# Metropolitan Planning Commission

Part A Deferred Items &  
Zoning Request

April 24, 2008

# **PREVIOUSLY DEFERRED ITEMS**

**BELLE LAKE DRIVE**  
(PRIVATE DRIVE)

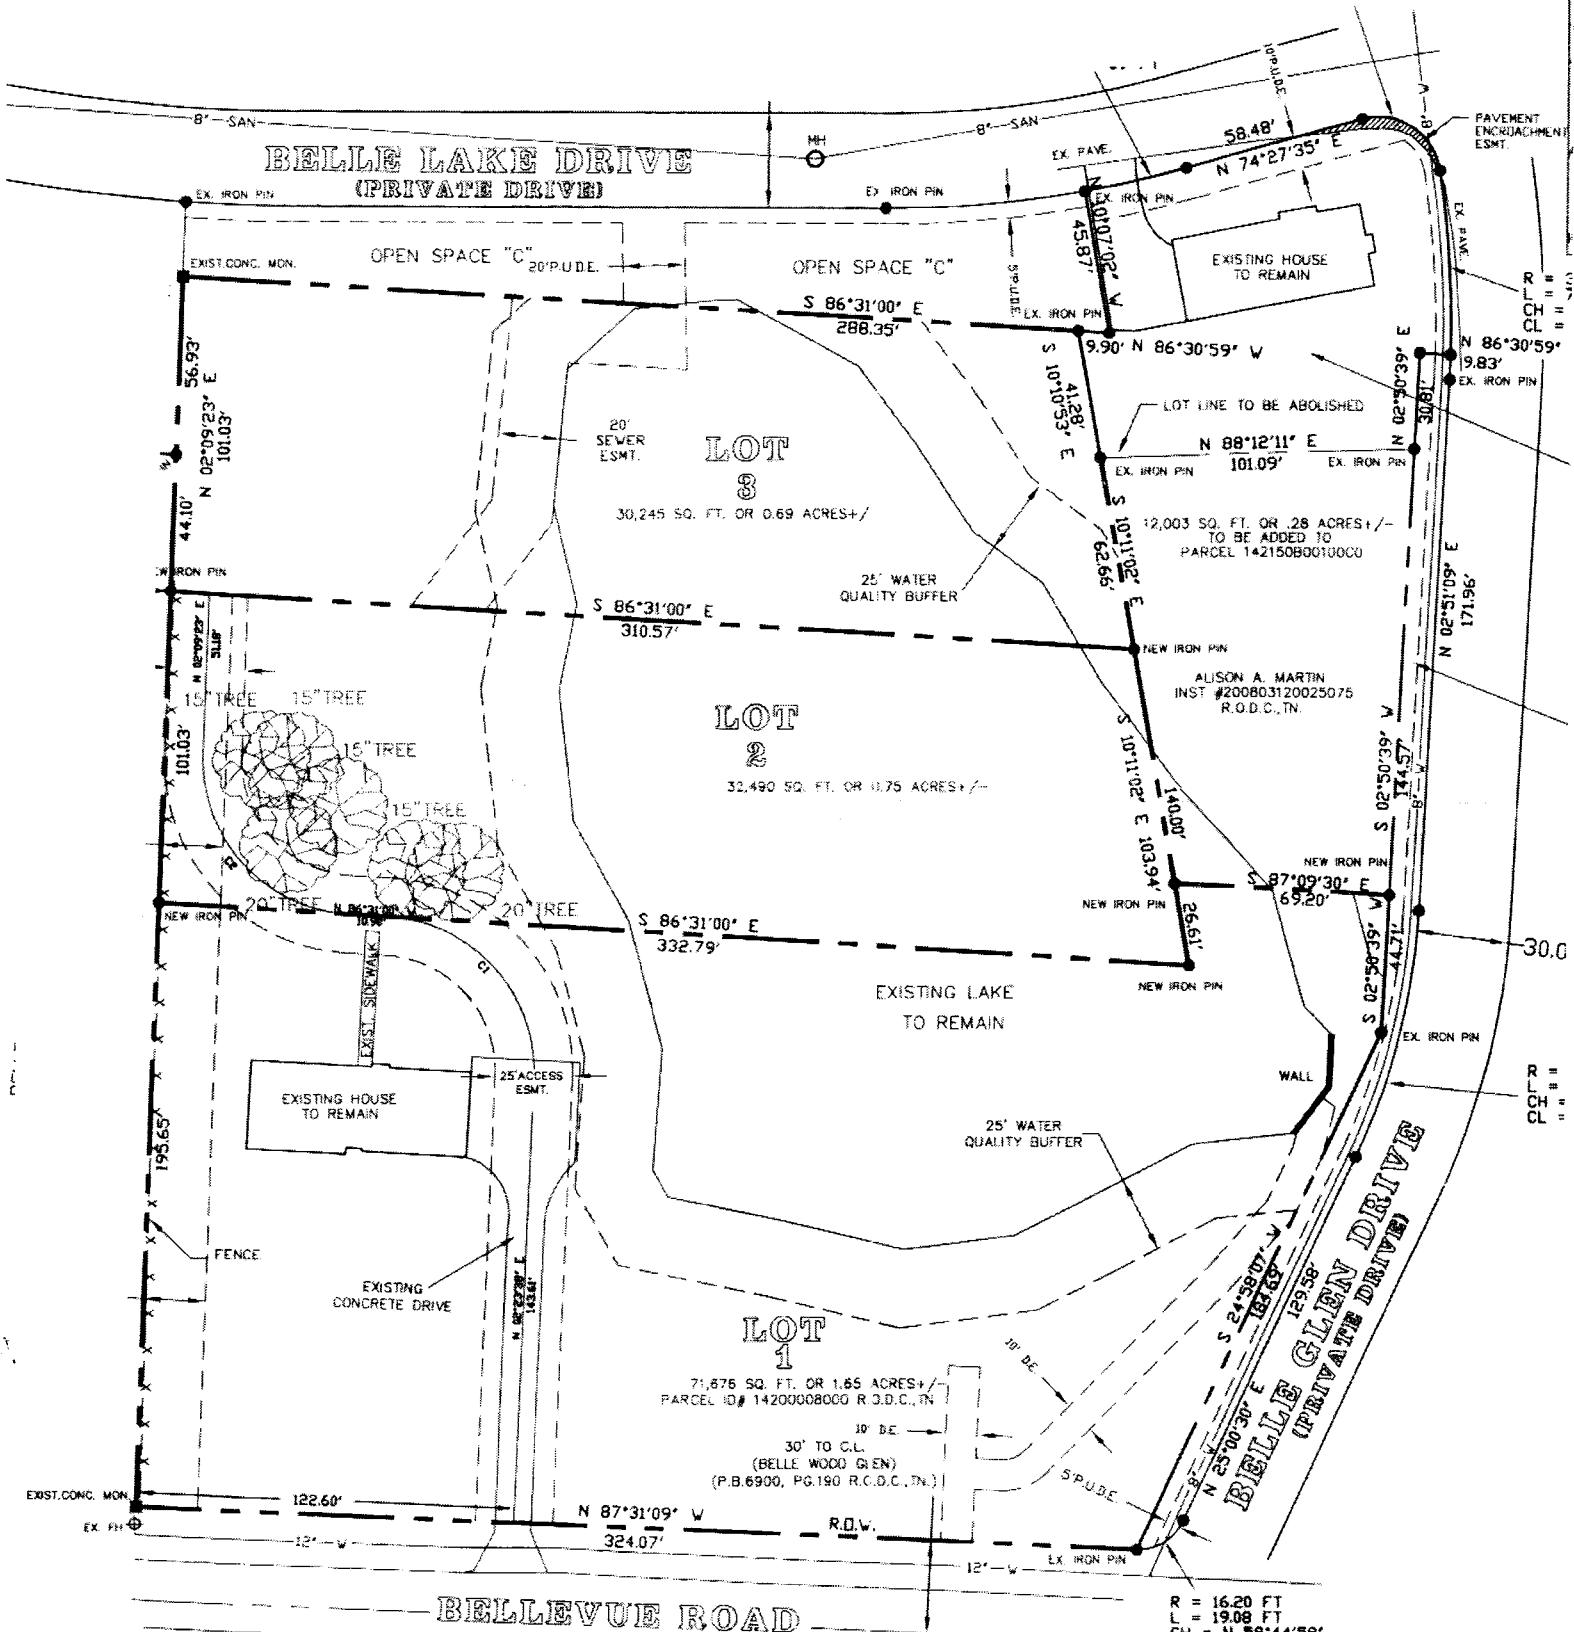
Section 3-4.2.b of the Subdivision Regulations requires all residential lots to have street frontage. This request creates two lots with no street frontage. The applicant has submitted a variance request stating that the lake, existing house, and private drives create a hardship for developing this property. However, these conditions were created by the owner or the previous owners. The PUD that limits the access was subdivided from a larger parcel that also included this property. Additional access was eliminated by that subdivision. Self-made conditions do not constitute a hardship.

It may be appropriate to permit the development of one additional lot. The additional lot could be accommodated without dividing ownership of the lake, which would eliminate maintenance issues with multiple owners. An access easement may also be sufficient access for one lot. Two additional lots is an

Staff recommends disapproval because the request does not meet the Subdivision Regulations for street frontage.
